ITEL MOBILE LIMITED

FCC Class II Permissive Change Request Letter

RE: FCC Permissive II Change Request for Company: ITEL MOBILE LIMITED

FCC ID: 2AJMN-A6611L

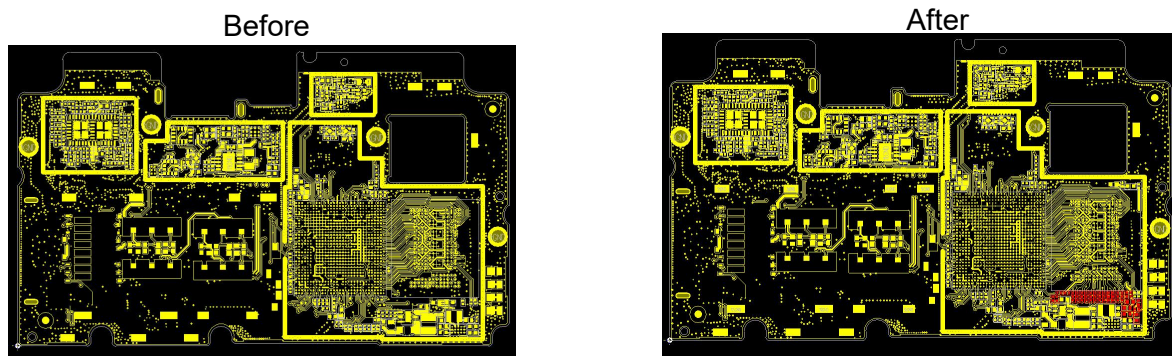
We are submitting an application for a class II permissive change to the FCC approval of the Company name: ITEL MOBILE LIMITED , product description: Mobile Phone (FCC: 2AJMN-A6611L, Original Grant Date: 08/24/2025). Here are the changes:

1. Revision Points The mainboard' s storage solution is revised from discrete configuration (LPDDR3 + eMMC) to integrated EMCP memory. The detailed changes are as follows:

Change	Before	After
R0540-R0551	NC	Resistor,0 ohm,0~0.05 ohm,1/20W,0201
R0552-R0563	NC	Resistor only pads are reserved for discrete memory configuration.
C0554-C0556	NC	Capacitor,100nF,±20%,6.3V,X5R,0201
C0557	NC	Capacitor,1uF,±20%,6.3V,X5R,0201
C0553	NC	Capacitor,2.2uF,±20%,6.3V,X5R, 0.5±0.07mmH,0402
C0550	NC	Capacitor,10uF,±20%,6.3V,X5R,0402
R0550-R0551	NC	Resistor,0 ohm,0~0.05 ohm,1/16W,0402
